LiDAR Quality Assessment Report

MT_Helena_2012

As stated in the Statement of Work for Acquisition and Production of High Resolution Elevation data for the Helena City area, this LiDAR operation was designed to create high resolution data sets that will establish an authoritative source for elevation information for the state of Montana.

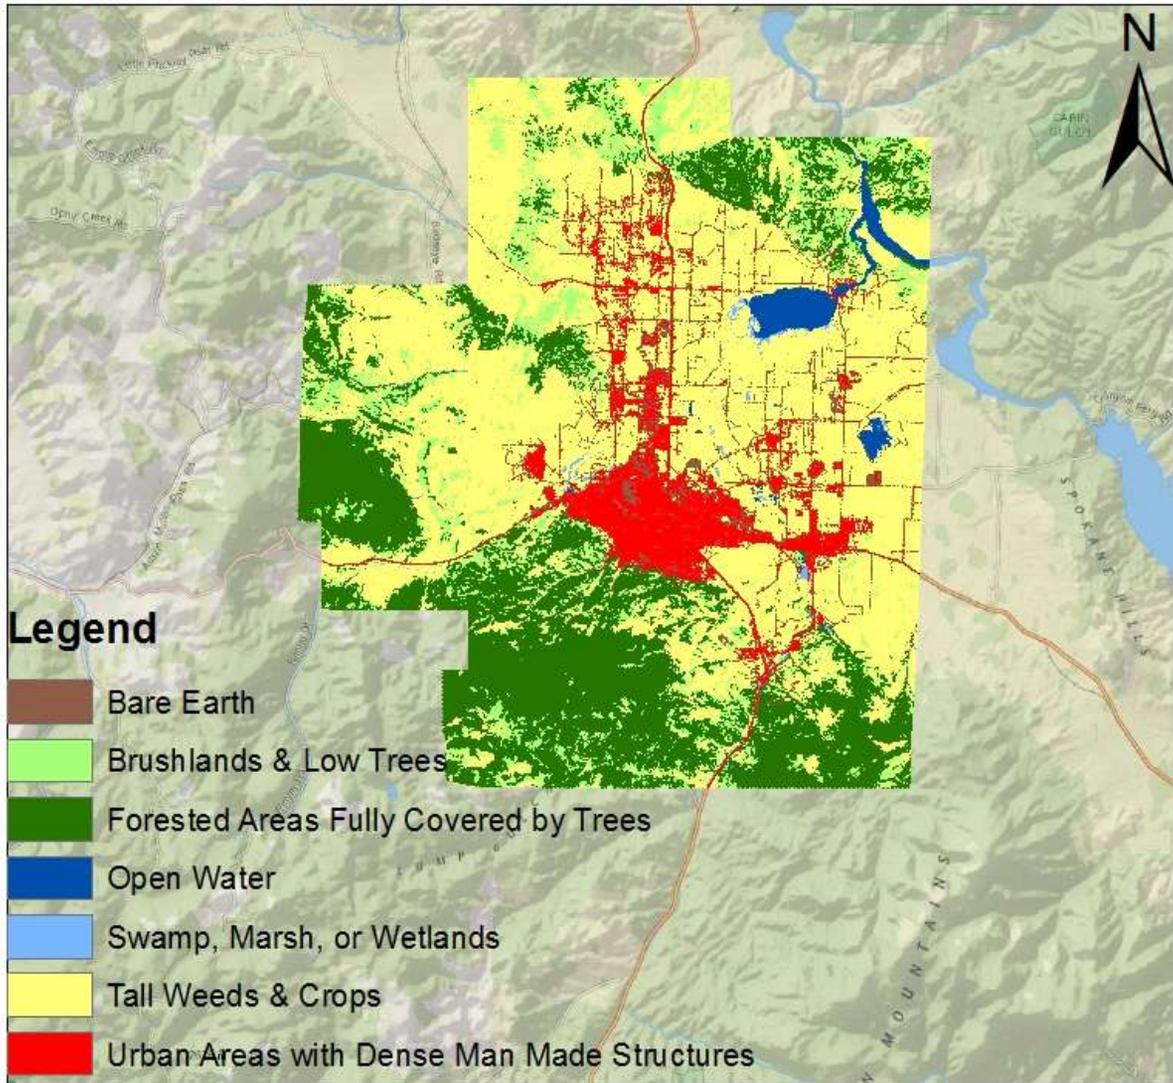
A total of 12 Checkpoints were identified via the Ariel Triangulation Report for the Helena Block. NGTOC used this table to create a Checkpoints Shapefile and assessed vertical accuracy off these points in addition to the 22 points listed under the Sanborn "Final_Report_Lewis&Clark_2012". The FVA using these 12 points was 0.219 M

Hill-shaded DEM

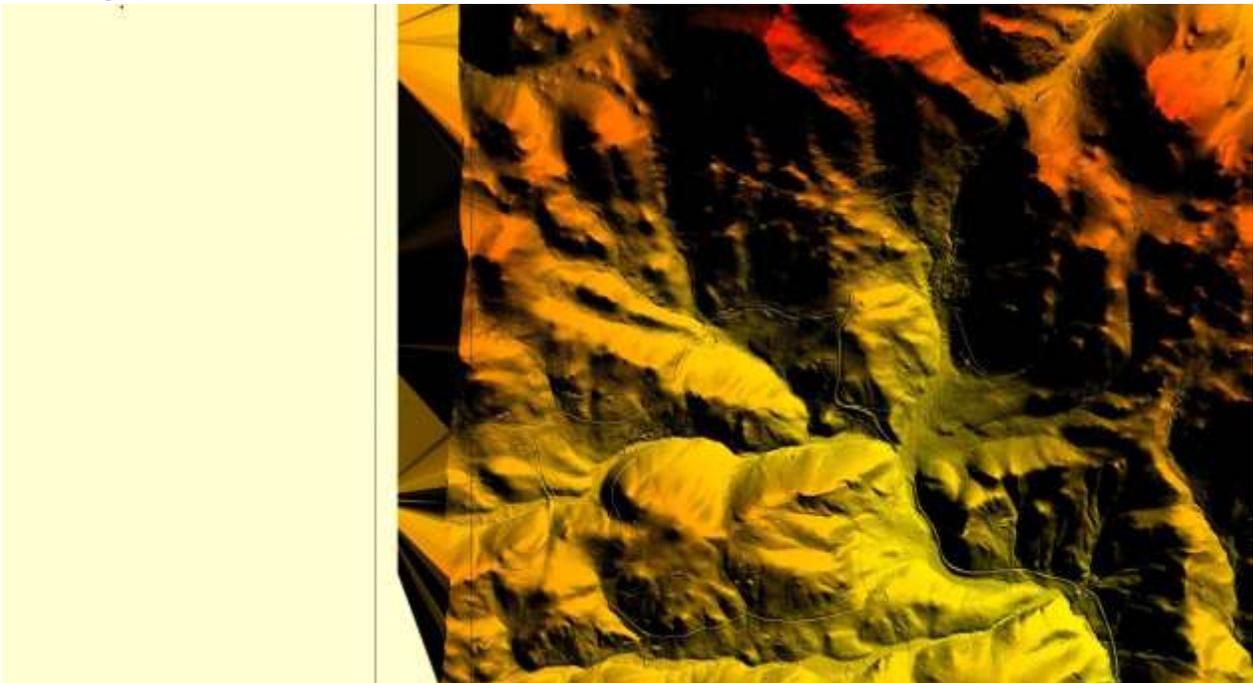
There is Edge Tinning throughout the borders of the DEM, these are an interpolation artifact from Gridding of a TIN. They can be removed by adjusting the project boundary and clipping out the bad areas or mosaicking only the adjust project extent.

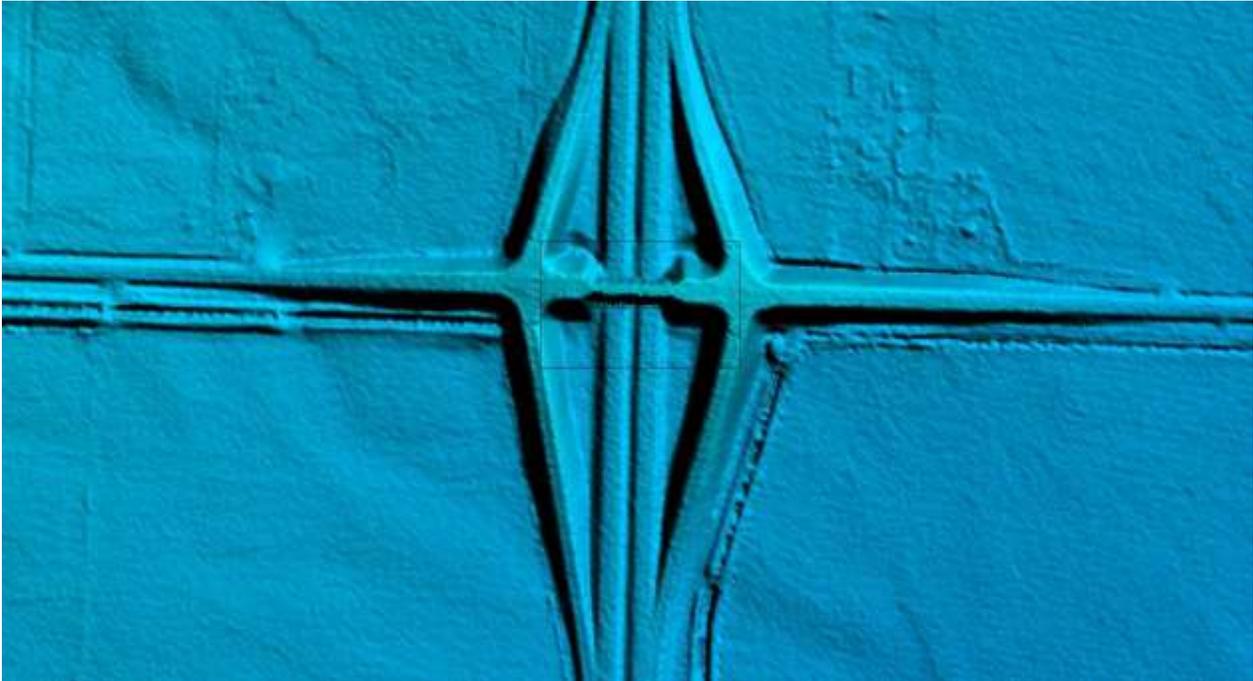
Another Example of an Edge TIN Artifact.

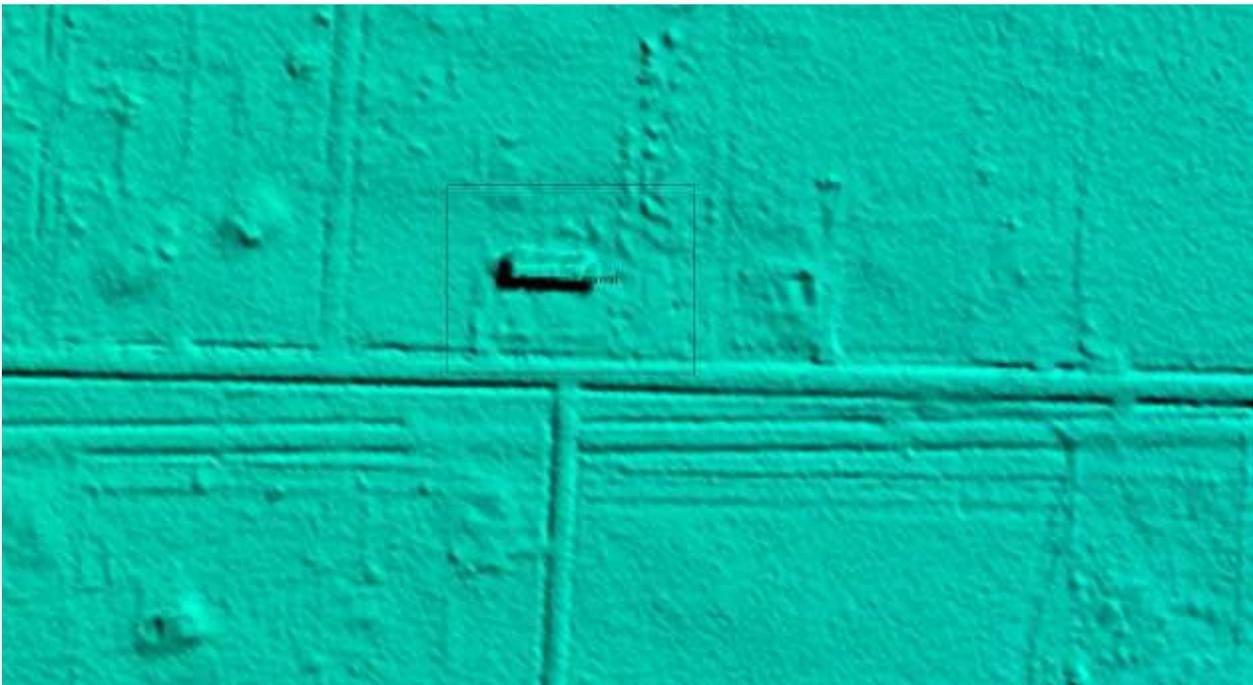
There were a total of 6 Bridges detected which were not removed.

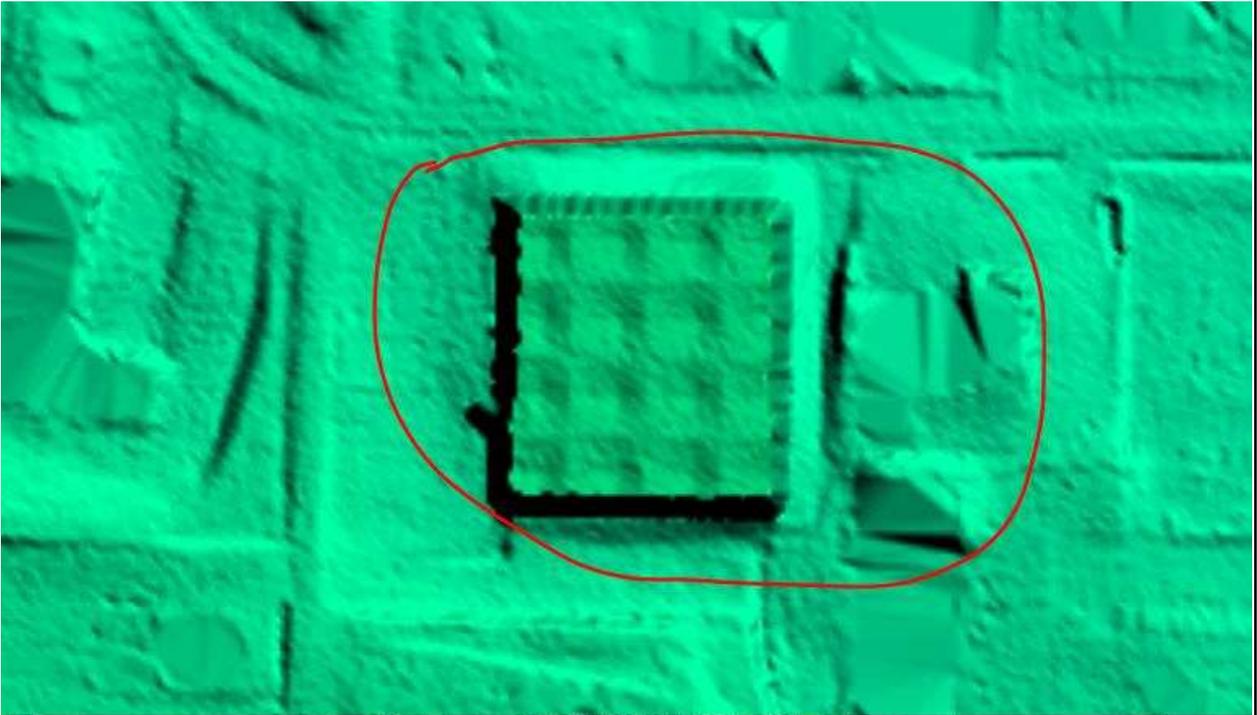
There were 13 structures found which were not removed from the DEM, some very small (above) and other larger (below).

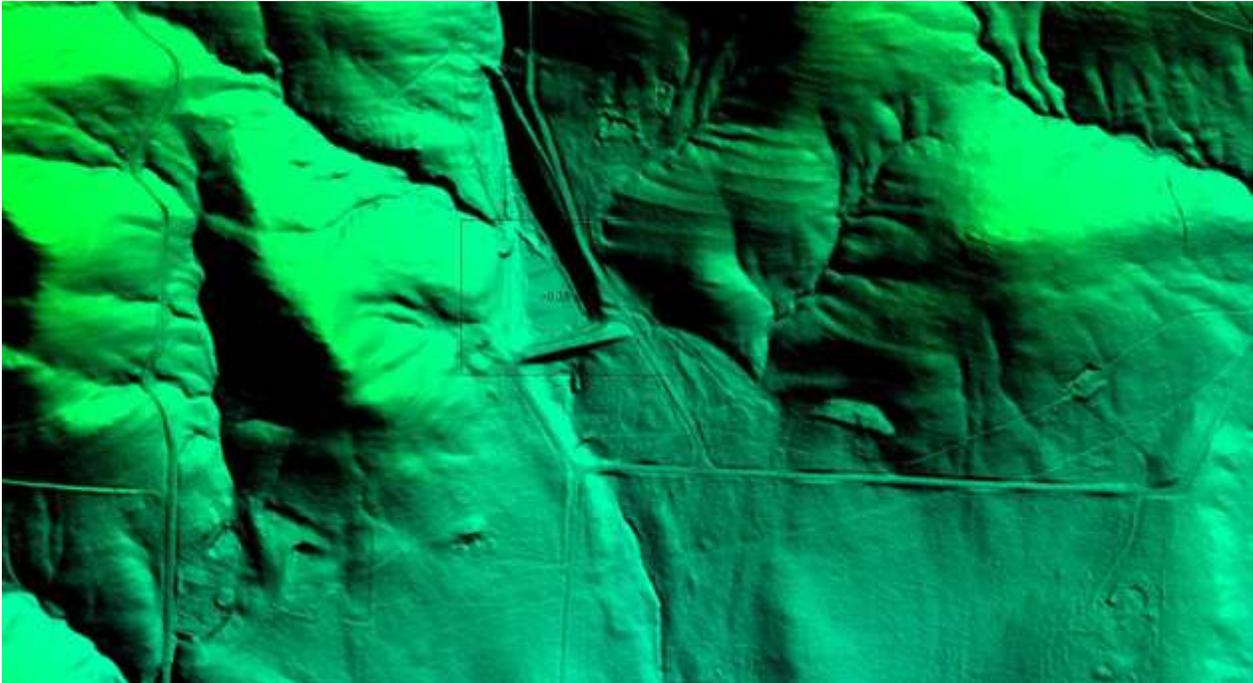
Structure Removal.
